The Commission has issued the enclosed Amendment No. 109 to Facility Operating License No. DPR-59 for the James A. FitzPatrick Nuclear Power Plant. The amendment consists of changes to the Technical Specifications in response to your application dated December 23, 1986, as supplemented March 13, 1987.

The amendment changes the Technical Specifications to permit fuel reloading and Cycle 8 operation. Included in the Cycle 8 core will be four Westinghouse QUAD+ demonstration fuel assemblies.

Amendment No. 109
License No. DPR-59

SUPPORTING AMENDMENT NO. 109 TO FACILITY OPERATING LICENSE NO. DPR-59

Figure 3.1-2
Operating Limit MCPR
 Versus τ (Defined in Section 3.1.B.2)
FOR ALL FUEL TYPES

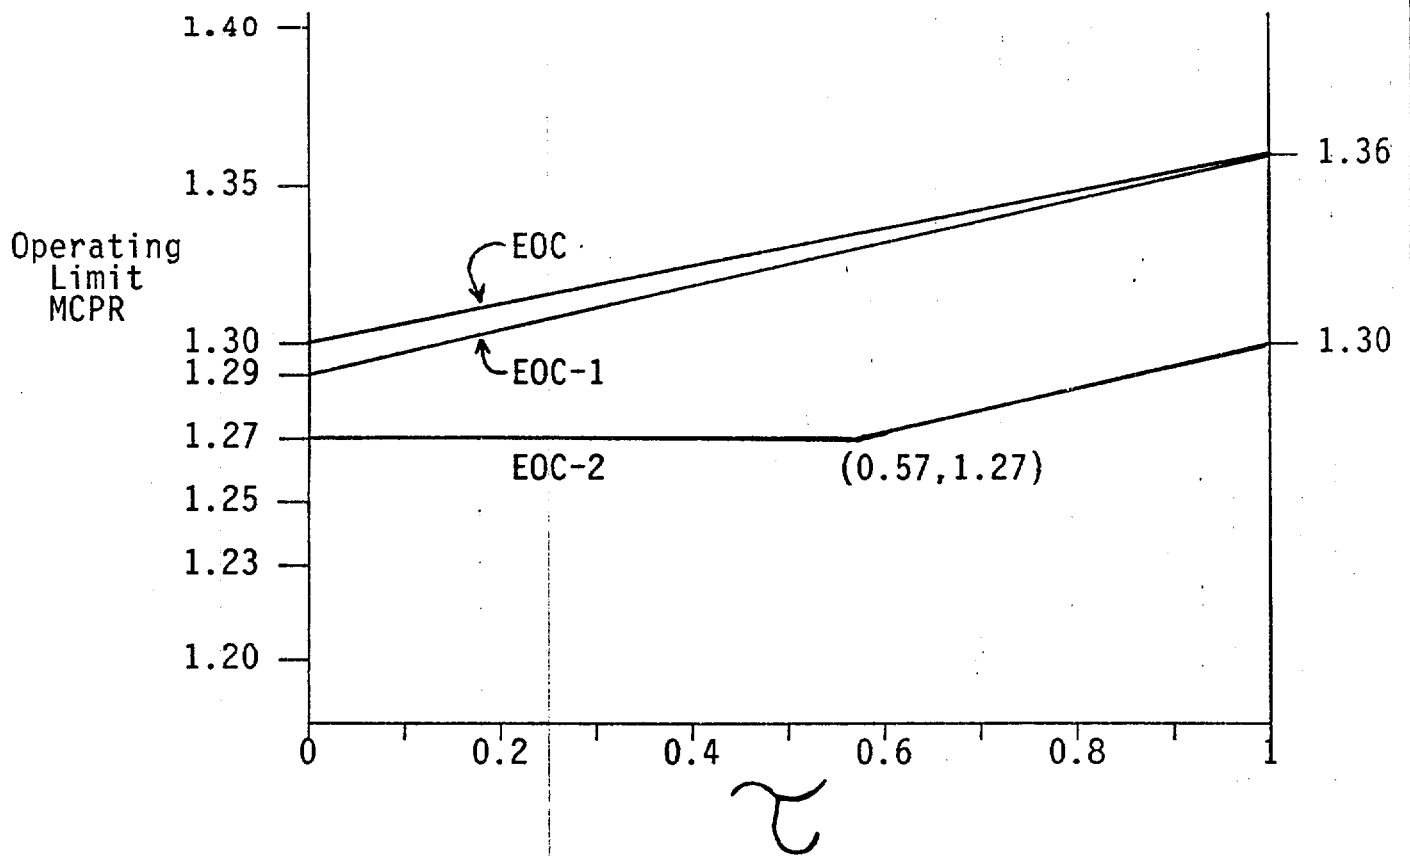
2. If requirement 4.1.E.1 is not met (i.e. $\tau_B < \tau_{AVE}$) then the Operating Limit MCPR values (as a function of τ) is as given in Figure 3.1-2.

*Note: Should the operating limit MCPR obtained from this figure be less than the operating limit MCPR found in Specification 3.1.B.1 for the applicable RBM trip level setting then Specification 3.1.B.1 shall apply.

Figure 3.5-11

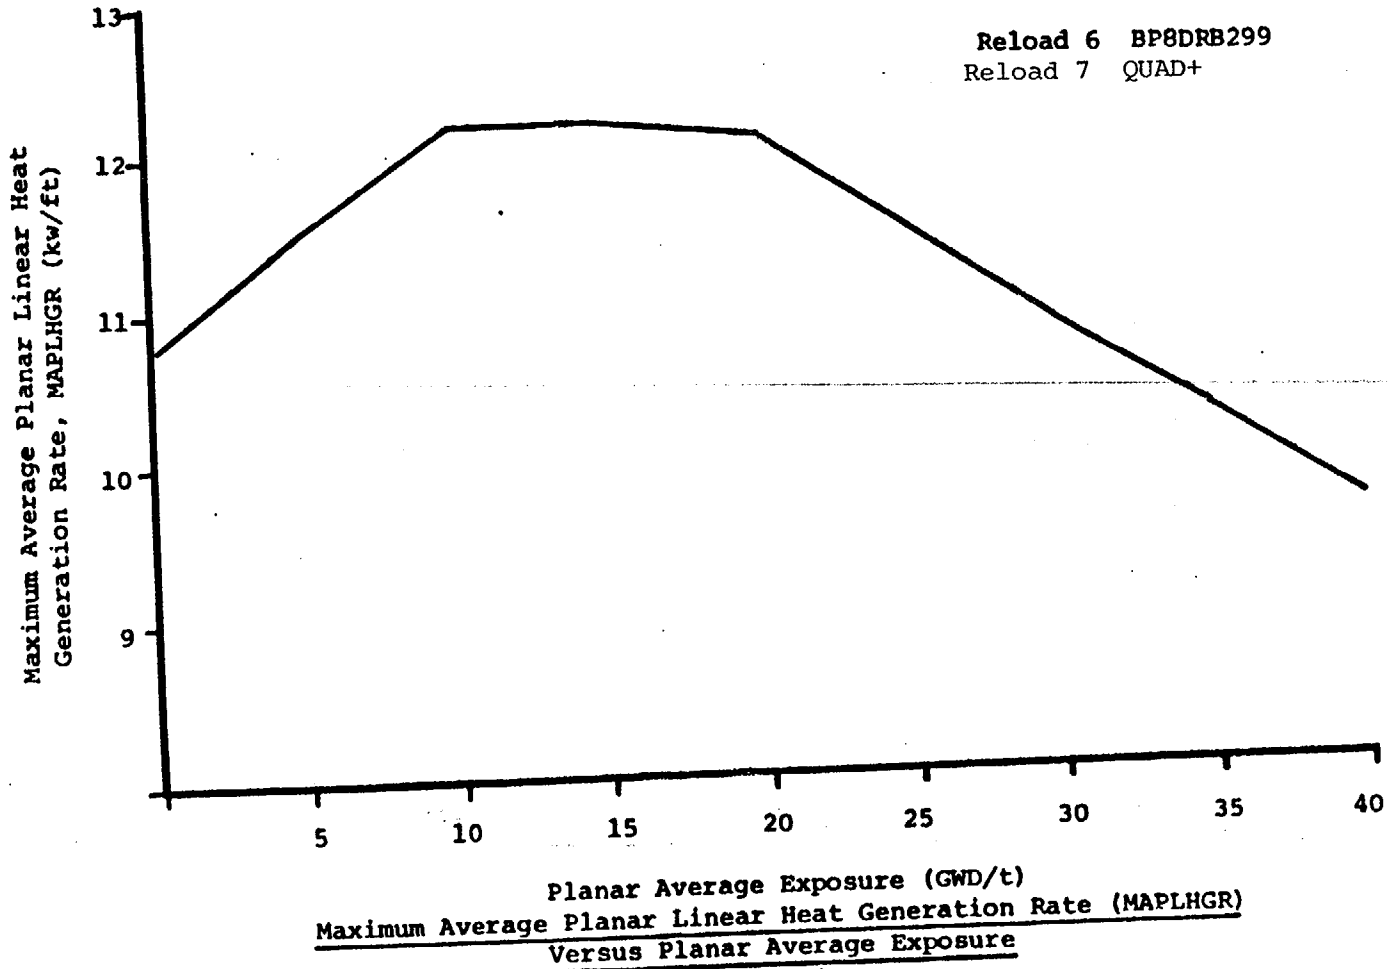
For single-loop operation, these MAPLHGR values are multiplied by 0.84.

Figure 3.5-12

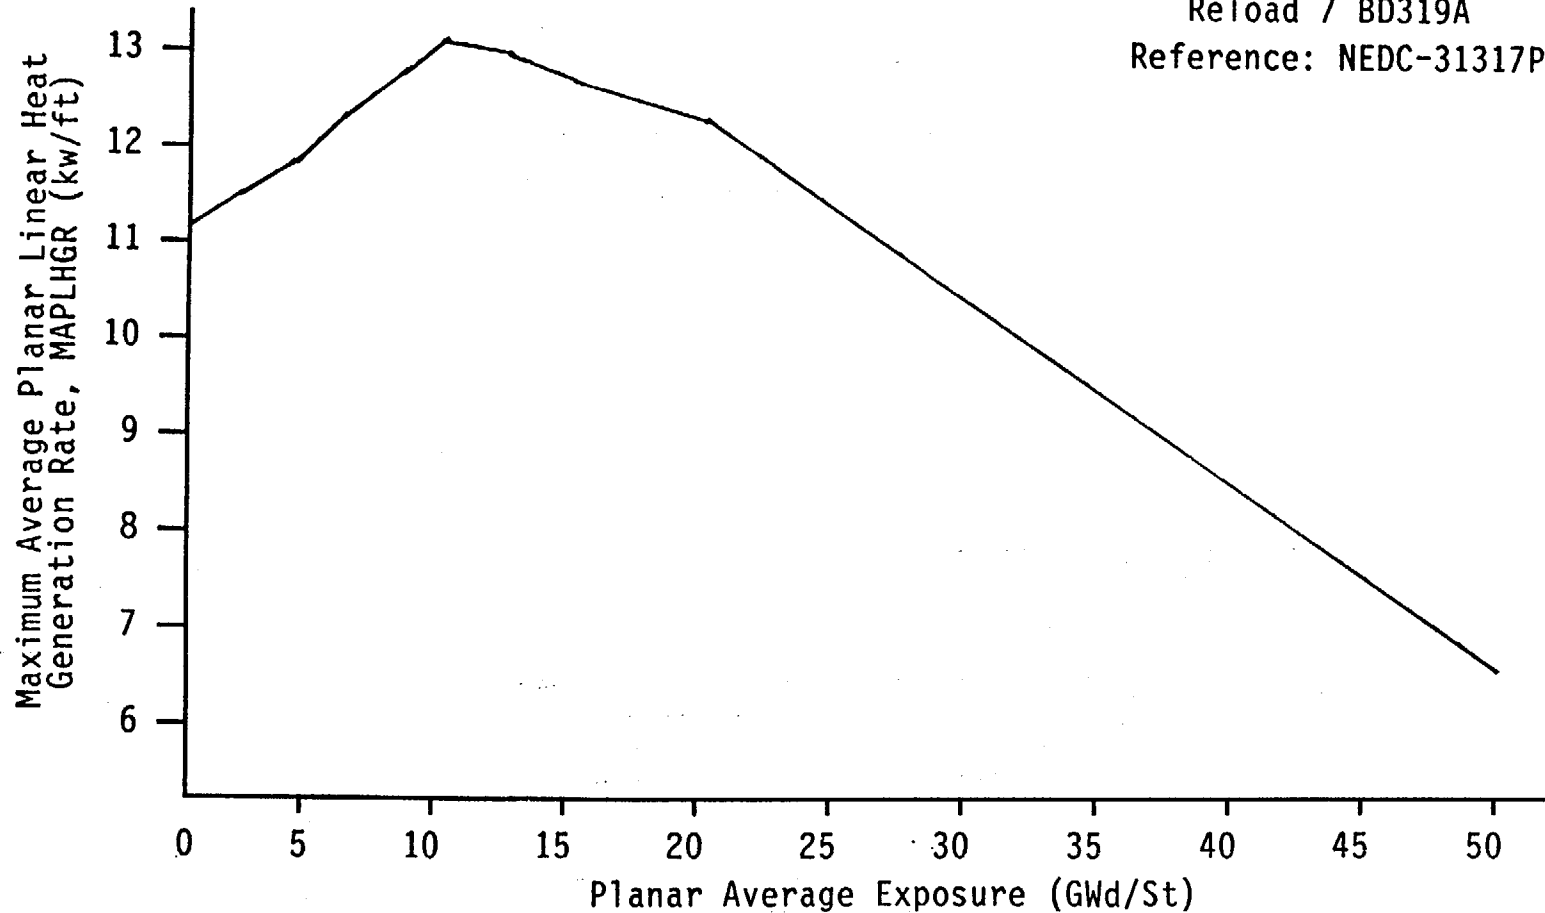
For single-loop operation, these
MAPLHGR values are multiplied by 0.84.

This curve represents the limiting
exposure dependent MAPLHGR values.
